2 - PORTALS - 18PA1
(END PORTALS @ U1 & U1')

MATERIAL: M270-50 (U.N.)	SURFACE PREP. & PAINT: SEE DWG GN1	HOLES: 1/8"	SHOP BOLTS: AS NOTED
DESCRIPTION: PORTALS			
CASCO BAY STEEL STRUCTURES, INC.			
75 SPRING HILL ROAD		SACO, MAINE 04072	
PHONE (207) 282-7360		FAX. (207) 282-1179	
STRUCTURE: Vermont Route 100A Bridge No. 14 Bridgewater County of Windor	DRAWN: RB	DATE: 10/7/10	
	CHKD: WJL	DATE: 10/19/10	
LOCATION: BRIDGEWATER, VERMONT	JOB NO. 454	DWG NO. 18AB	
PROJ NO. BRS 0149(4)	CUSTOMER: VT AOT	REV. 1

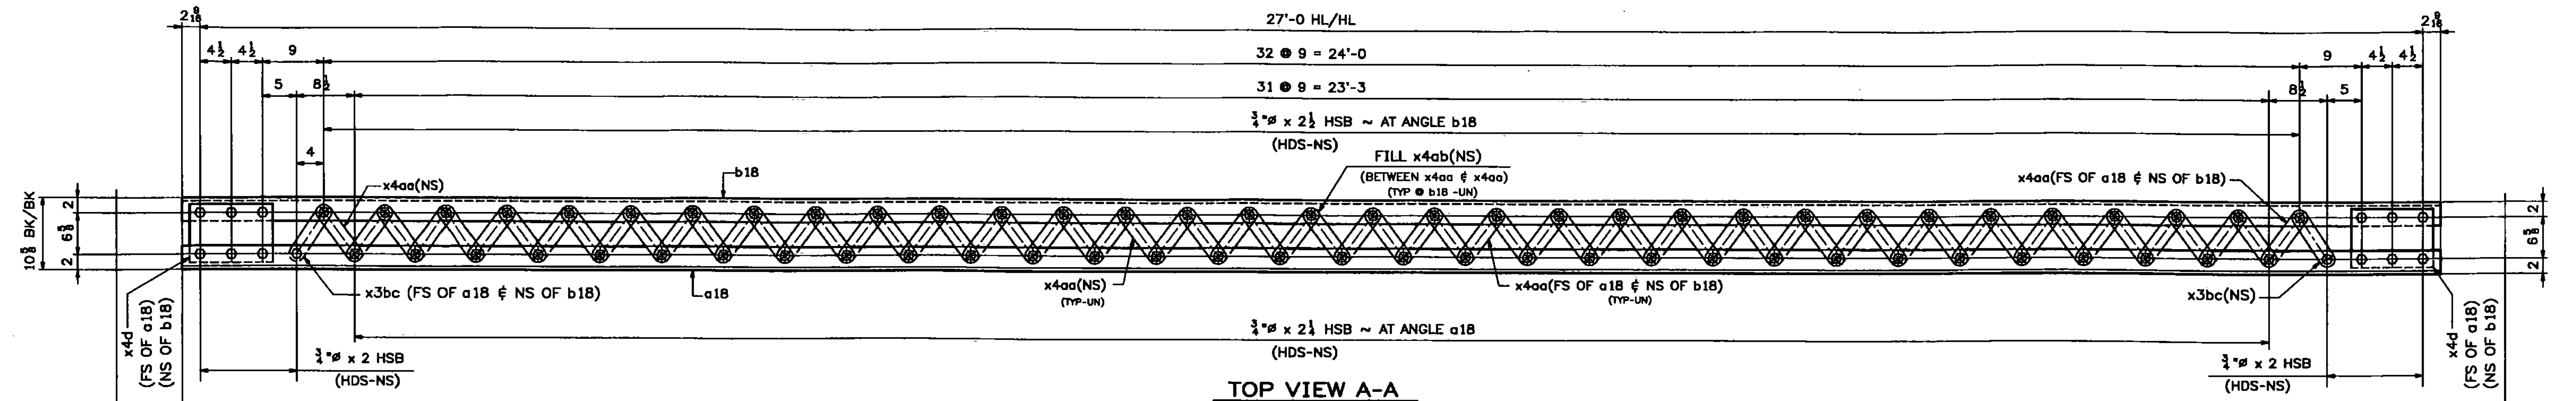
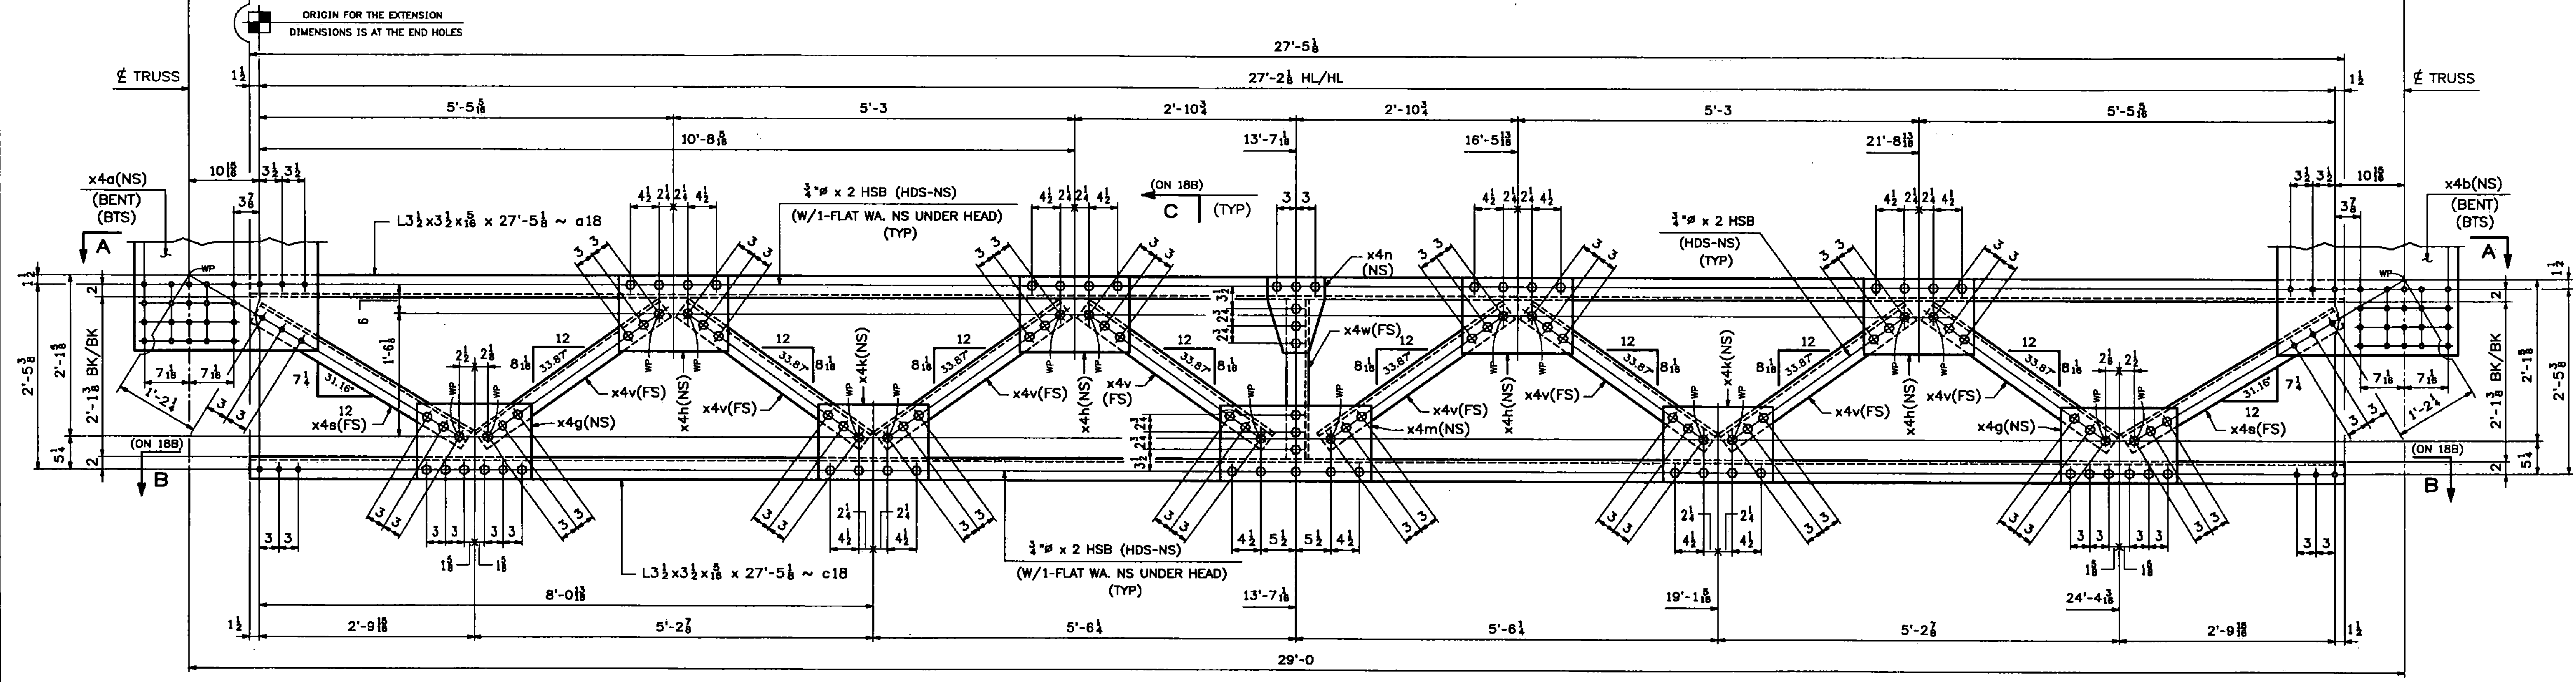
REV.	DATE	REMARKS	DWN	CHK	APVL	SHOP
03/24/11		REVISED BEVELS & ANGLES	JM	PWR		
03/02/11		REVISED AS PER APPROVAL COMMENTS	JM	PWR		
0

Vermont Agency of Transportation
RECEIVED
CK'D BY TCF OK'D BY SSS
7:43 am, Apr 12, 2011
RESUBMIT _____ APPROVED X
BY KMH DATE 4-12-11
